WATERLOO METRO QUARTER BUILDING 2

**SSD-10439 - RESPONSE TO SUBMISSIONS
SUPPLEMENTARY DESIGN REPORT**

This supplementary design report has been prepared to respond to Submission received for SSD-10439.

West Elevation

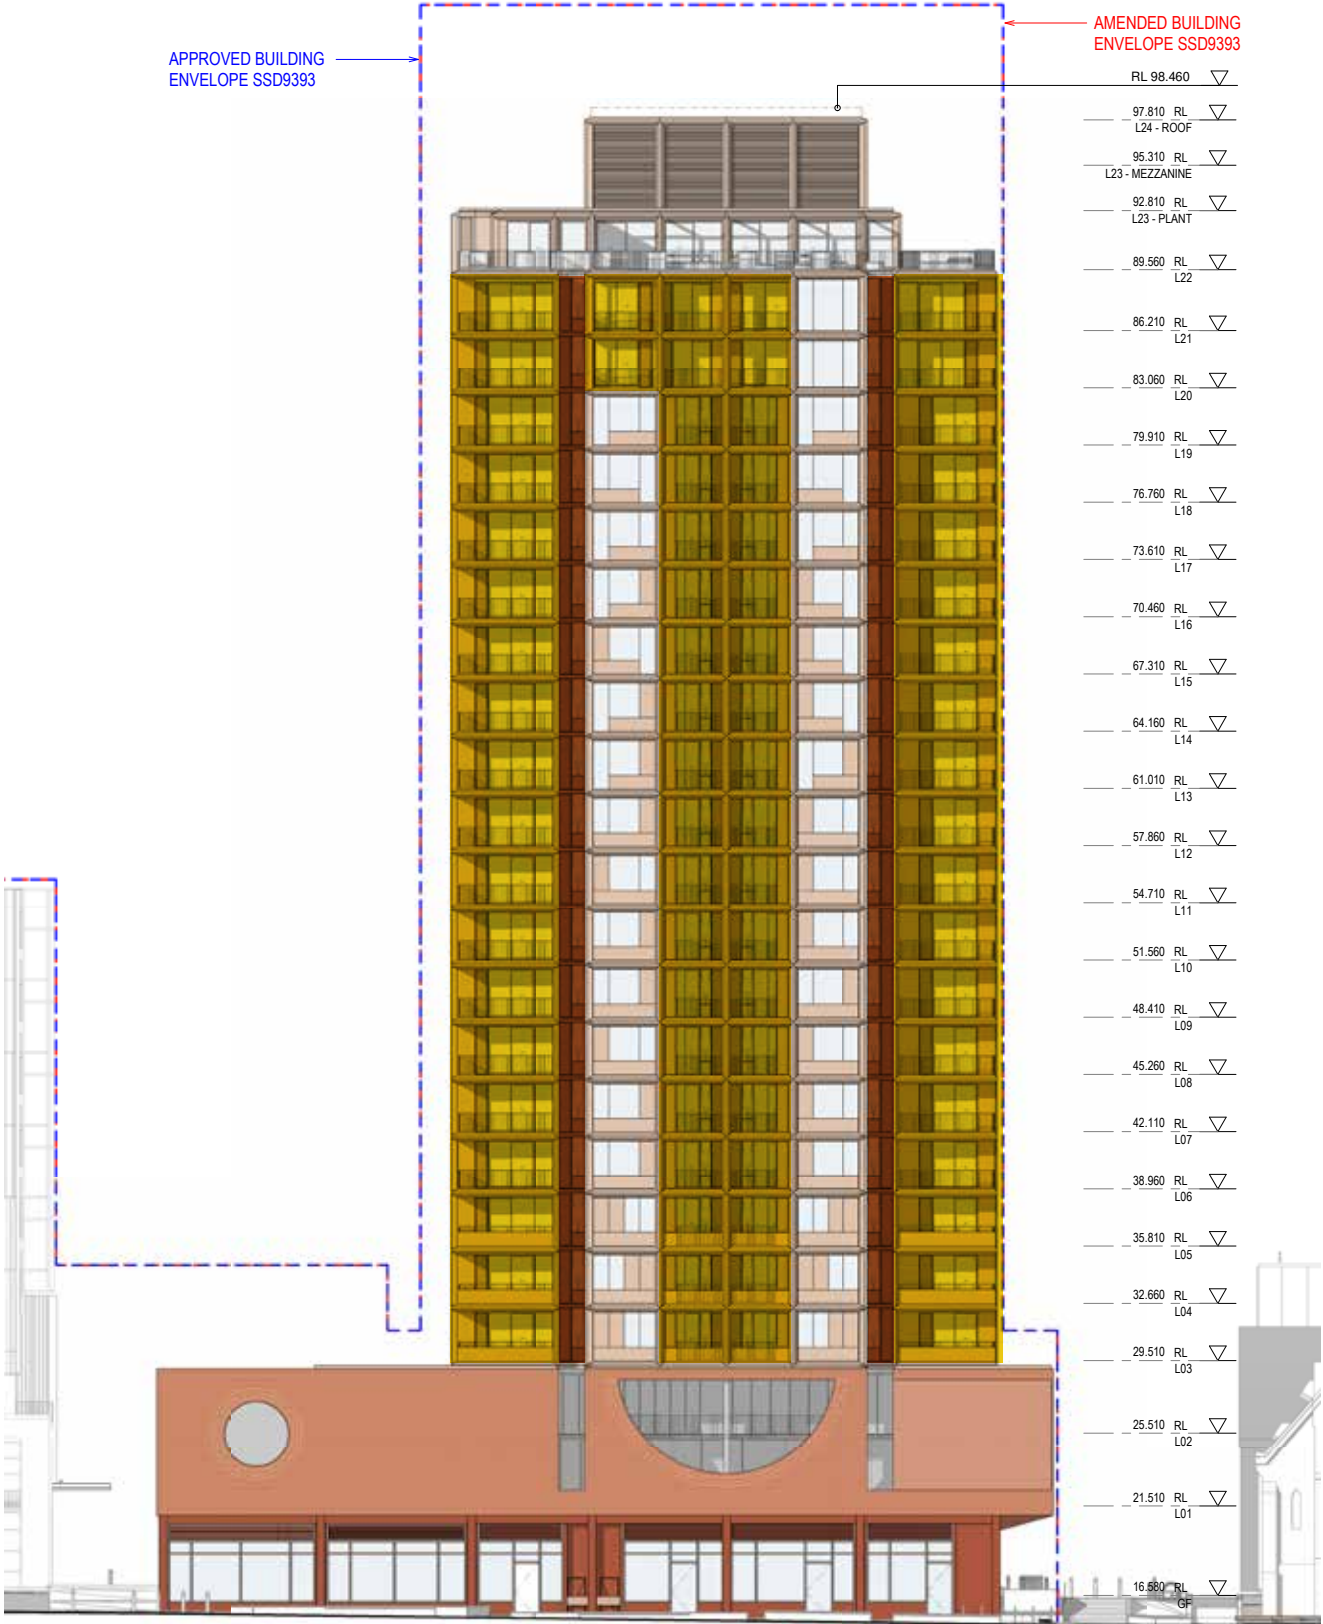
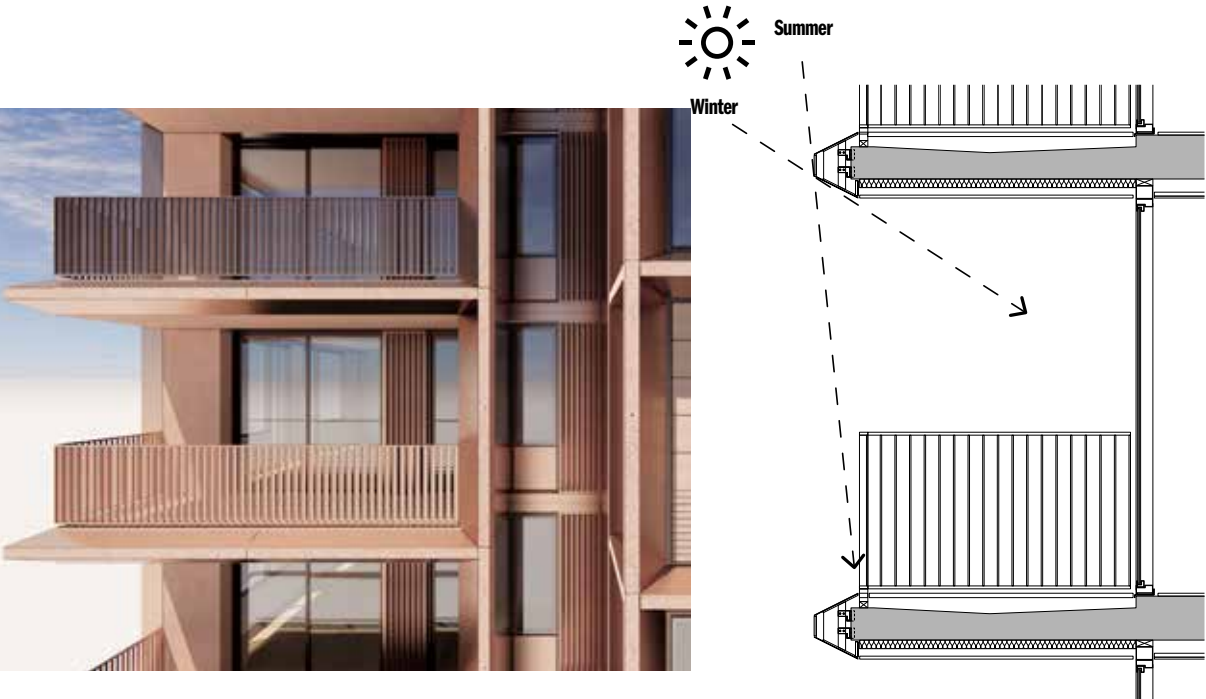
16 (f) Glazing type is not specified. Due west orientations will require thermal glass which will have negative impacts on reflectivity, heat reflection and outlook. A preferable solution is to have externally mounted, operable shading devices and clear glazing;

19. External sun shading – Contrary to Objective 4A-3 of the ADG, no sun-shading is provided to west elevation. Despite probable compliance with internal thermal targets via energy rating tools, the tower facade design does not provide residents with the means to passively shade and cool their home, particularly where economic circumstances prohibit the use of air-conditioning. These apartments are not designed to withstand extreme heat events. External, operable shading devices should be provided to all facades with exposure to mid-morning and mid to late-afternoon sun. Although passive shading is nominated as one of the measures in the Project’s Sustainability Framework (refer to page 34 App M, initiative 9.11.3), it is not delivered.

- _The west facade has a high level of shading with passively shaded balconies.
- _Balconies and setbacks within the built form are deliberately planned to provide effective passive shading to the majority of west facade.
- _The ADG objective 4A-3 recommends design features to facilitate shading that's not limited to shading devices. The submitted proposal adopts this recommendation to explore passively shaded balconies, horizontal shading projections and high performance glazing.
- _Aluminium framed double glazing (high VLT, low reflectivity) is proposed to all units. Performance glazing is proposed to reduce heat gains in addition to passive shading.

Stage 1 Concept Plan

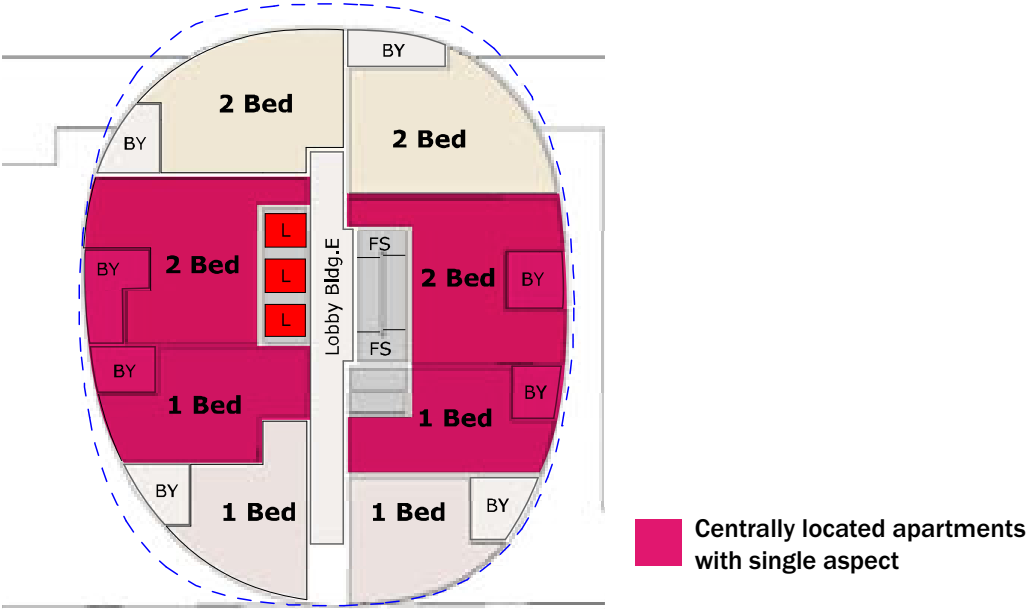
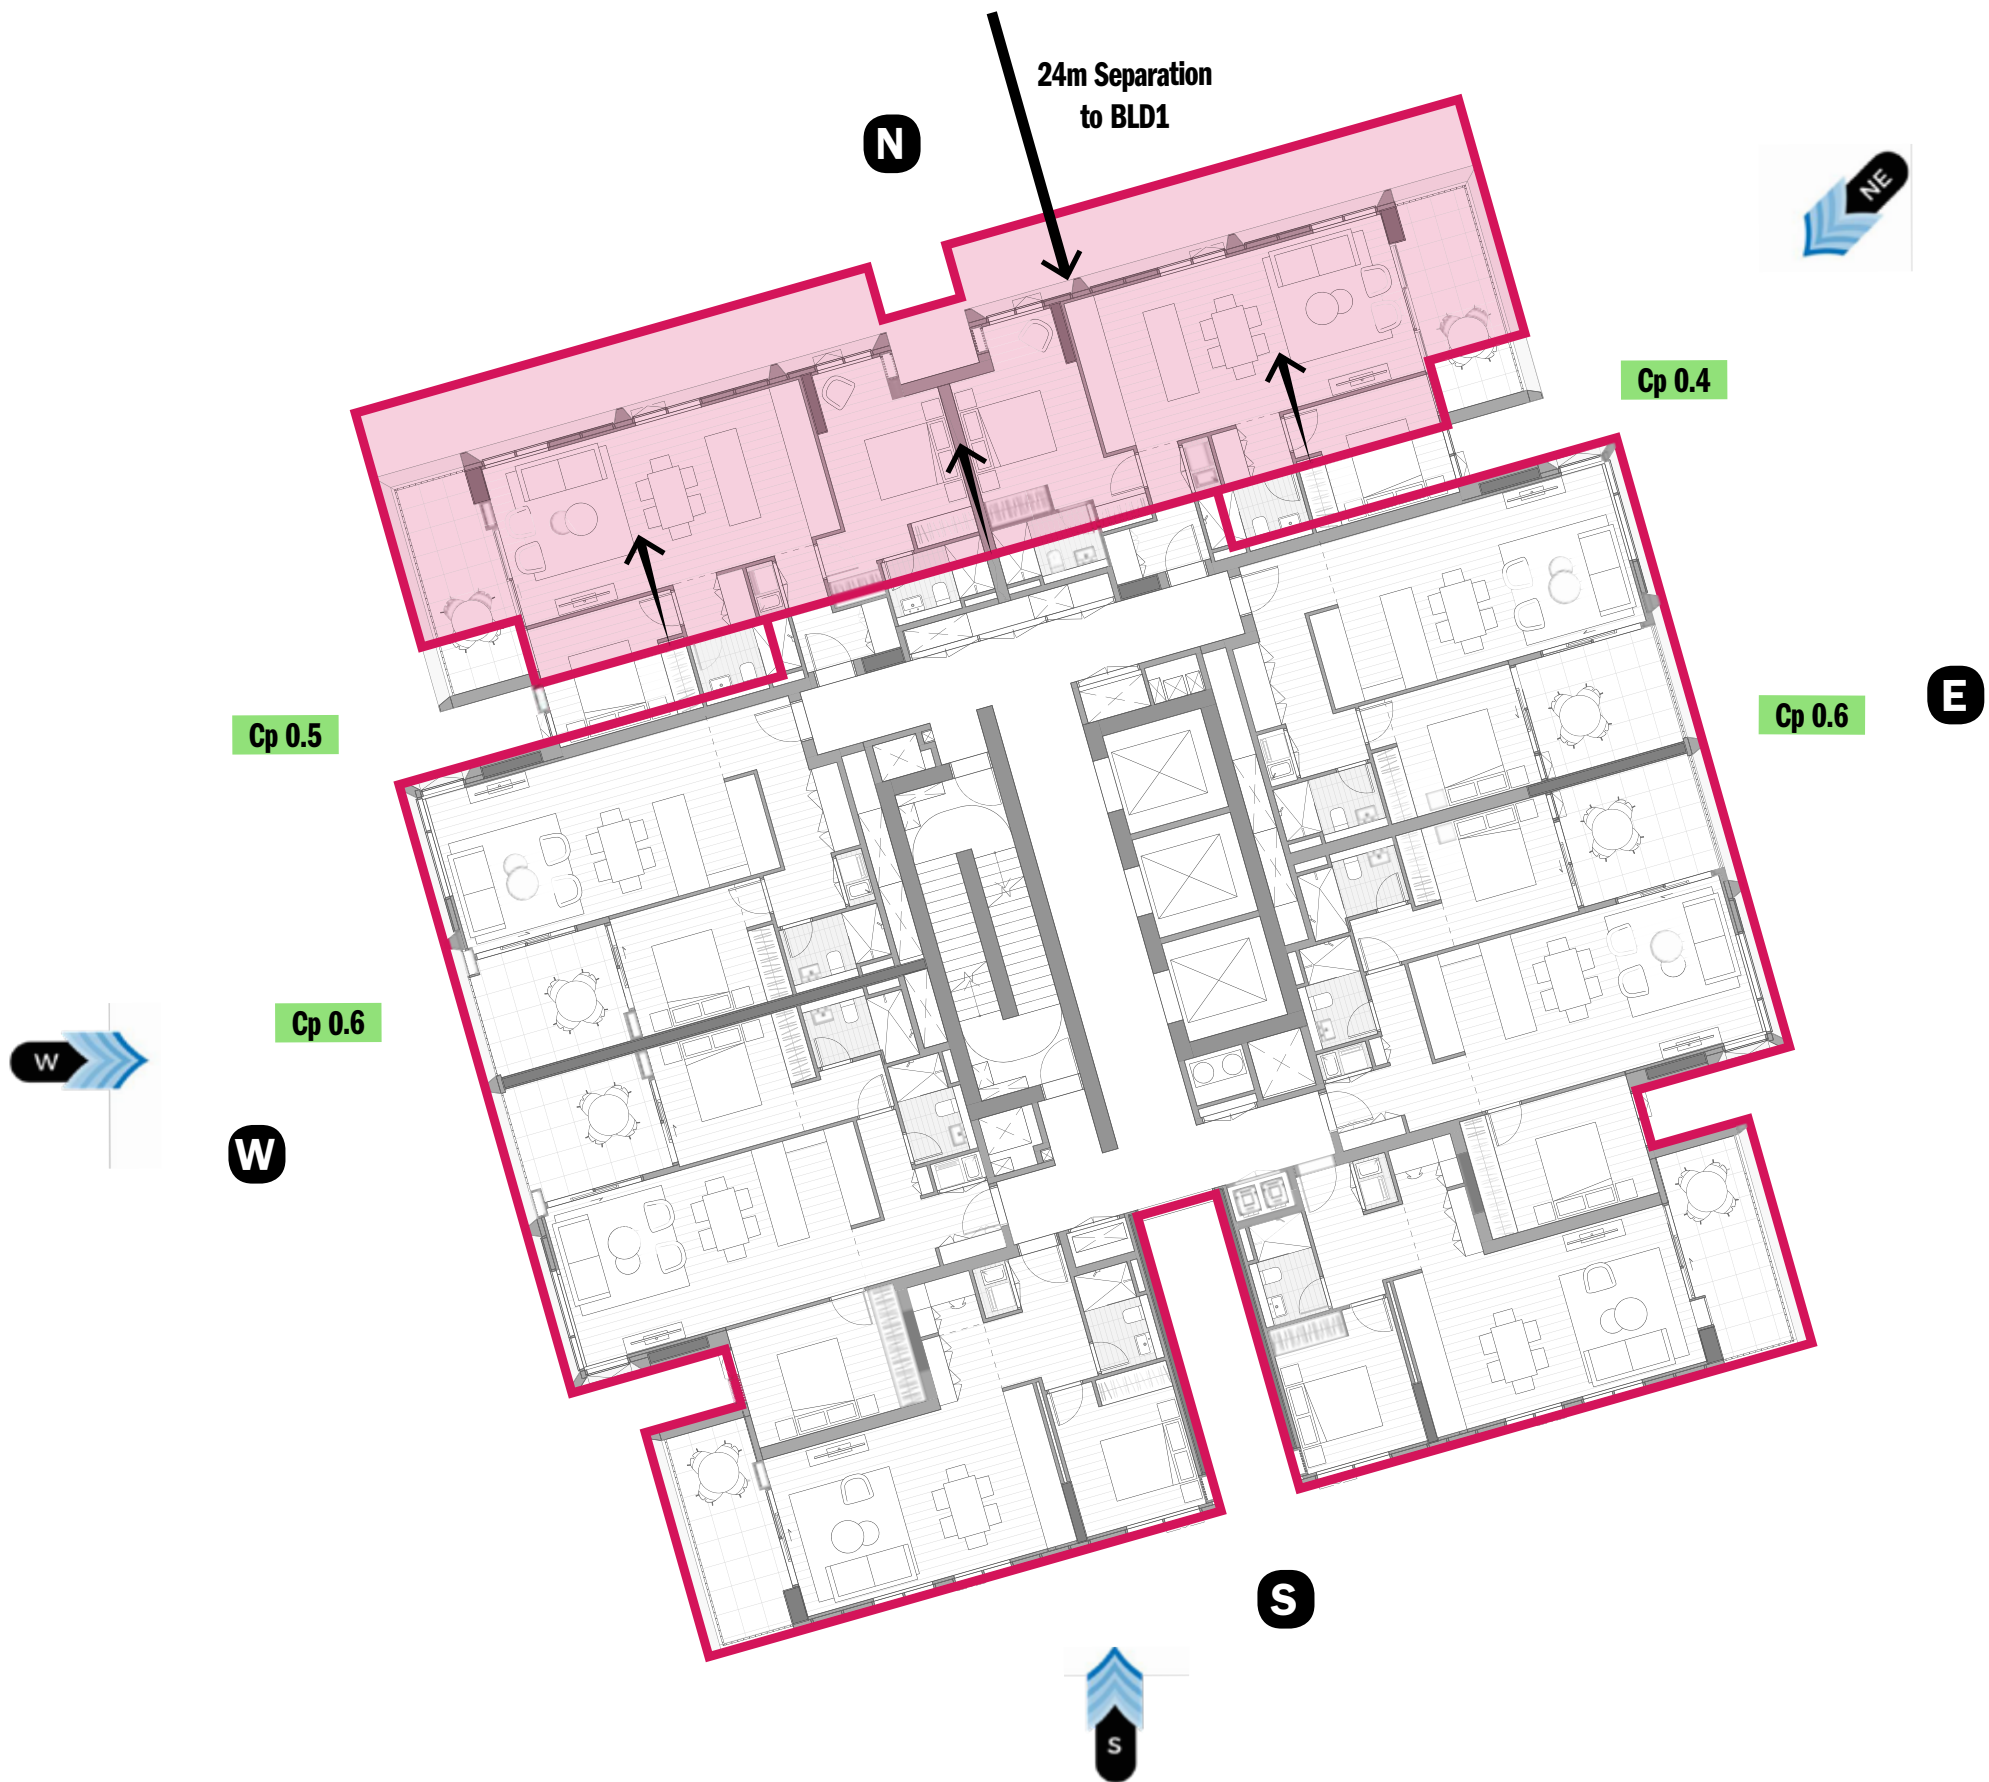
20. Natural cross ventilation – Objective 4B-3 of the ADG recommends a minimum 60% of apartments to be naturally cross ventilated. The applicant includes centrally located apartments as achieving natural cross ventilation, notwithstanding these do not meet the definition under the ADG. Furthermore, at least half of the apartments that do meet the definition of natural cross ventilation are noise affected and will require windows and doors to be closed to comply with Objective 4J-1. As such the development provides well below the minimum recommended.

Tracker Item 2.21 - The Panel accepts that the central apartment building layout can satisfy the minimum requirement for natural cross ventilation in the Apartment Design Guide. The Panel requests a diagram showing openable window locations in all apartments to clarify how this ventilation will be achieved, whilst maintaining visual and acoustic privacy between units.

- _The cross ventilation of Building 2 has been modelled based on prevailing wind directions and pressure differential at the openings to enable cross flow.
- _The stepped planning or setbacks in the design maximises apartments' ability to have more than one aspect with direct exposure to the prevailing winds, or windows located in significantly different pressure regions.
- _75% (36/48) of the residential apartments up to Level 8 (first 9 storeys) of Building 2 are considered naturally cross ventilated according to the ADG.

- _The Stage 1 Concept Plan presents 4 centrally located apartments on the north and south facade.
- _The submitted design improves upon the Stage 1 Concept Plan to maximise corner apartments, maximising not only cross ventilation but also view and solar.

- _Scheme 8 in Appendix 4 of the ADG shows a similar floor plan in design, consisting of 8 apartments per floor, centrally located apartments on two aspects and setback corner apartments.
- _This scheme notes the design qualities as possessing excellent natural cross ventilation provided.

Noise affected spaces to a typical level

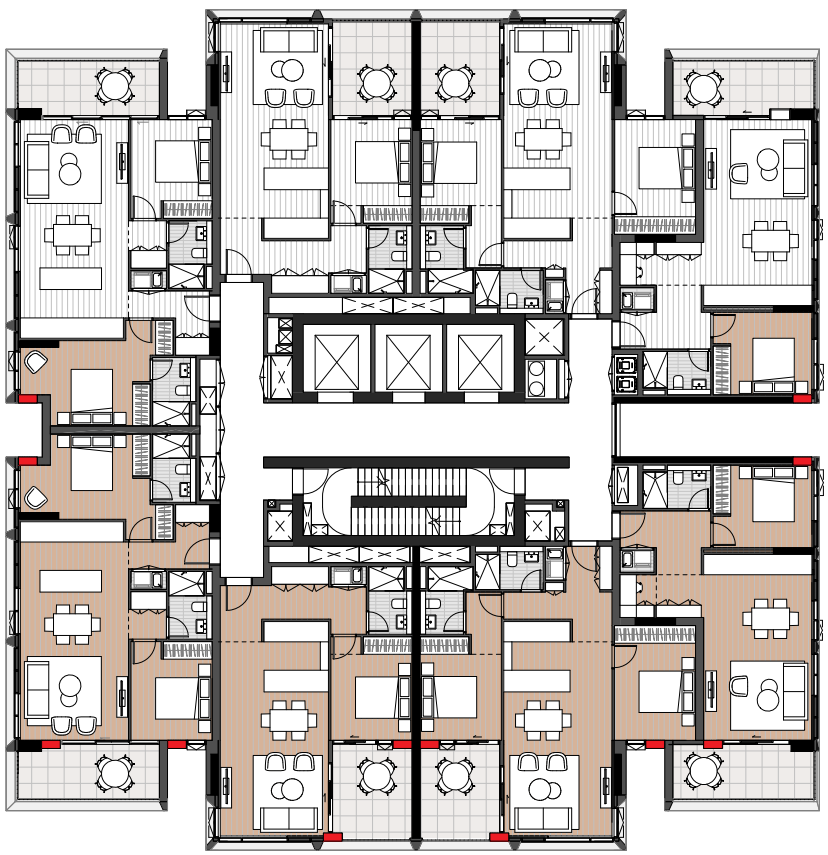
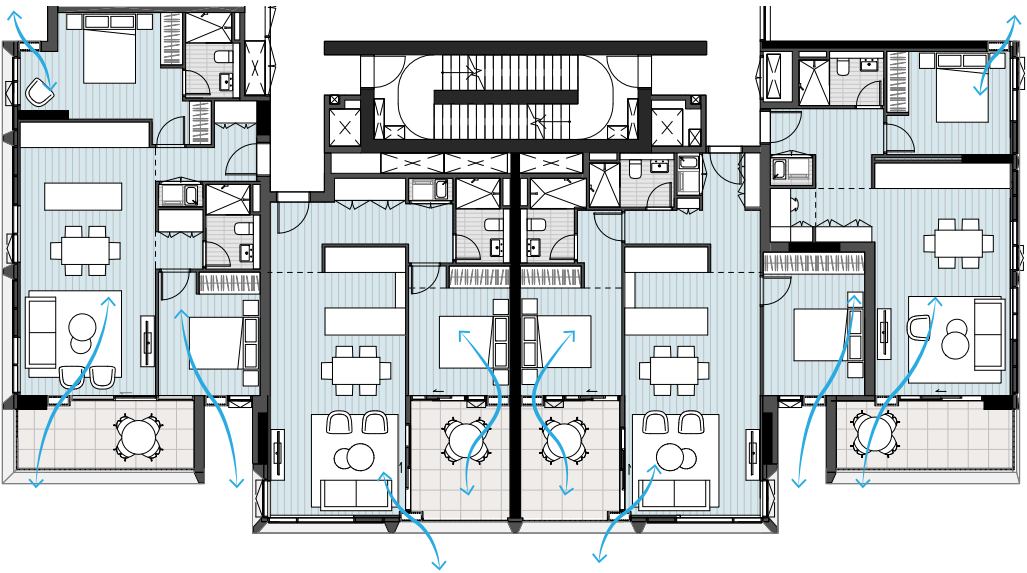
29. Objective 3B-1 of the ADG requires all habitable rooms to be naturally ventilated. Objective 4J-1 requires development in noisy or hostile environments to minimise the impact of external noise and pollution through the careful siting and layout of buildings. The applicant has identified apartments within the central and southern precincts as being noise affected and requiring acoustically attenuated natural (non-mechanical) ventilation systems to meet these objectives.

32. Where windows are required to be closed and an alternative ventilation strategy proposed, the development must demonstrate that the criteria under Clause 102 (3) is met without the 10dB variance.

- _The noise affected apartments on the north, west and south facade are designed with acoustic ventilators to allow natural air flow into the apartment without the requirement of opening a door or window.
- _CFD modelling undertaken by Stantec.
- _In the CFD modelling, the road noise from Botany Road has been measured both before and during COVID-19. The monitor on Botany Road was installed in a location similar to that of SLR's monitoring location for the Concept SSD DA.
- _The acoustic privacy was assessed in-line with the criteria outlined in Sydney DCP 2012 and the requirement of the Waterloo Metro Quarter Design & Amenity Guidelines. The proposal achieves the criteria set.
- _Please refer to Memo prepared by Stantec for further clarification.

Shared Rooftop Terrace Plan

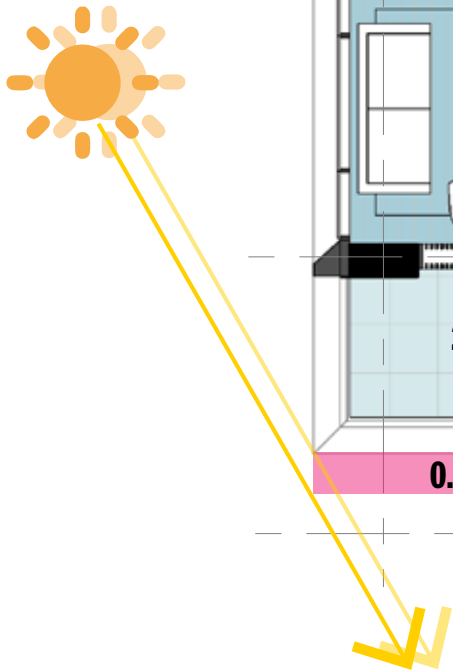
21. Communal open space - Communal outdoor space is underprovided at 186sqm on level 22. According to the application, this equates to 7.5% of the site area, in contrast to the minimum 25% minimum recommended under Objective 3D-1 of the ADG. The wind analysis concludes that the terrace only achieves 'walking' comfort criteria in summer, and 'standing' conditions for the winter period. Neither is acceptable – the communal open space should be suitable for 'sitting' activities.

_The applicable site area of the Central Building is 2,460sqm. Whilst the proposed development seeks a departure from the requirement for a communal area equal to 25% of the site, the proposal achieves the objective of the control which is to: Objective 3D-1 An adequate area of communal open space is provided to enhance residential amenity and to provide opportunities for landscaping.

- It is located on Level 22 and benefits from excellent solar access and view amenity. The large sliding doors opens up the indoor communal area, creating a seamless connection between the indoor and outdoor communal space.
- It provides direct and accessible access for all residents, including affordable housing residents from a common circulation area. The communal terrace will provide shade and space for undercover activities, landscaped planters and a community garden.
- Within the immediate vicinity of the proposed building, residents have access to high quality public spaces and amenities both within the WMQ site and surrounding neighbourhood.
- Communal open space area has been maximised, the podium rooftop is provided for the play space of the childcare centre, and considering this and the site area, the roof top space is adequate for the development
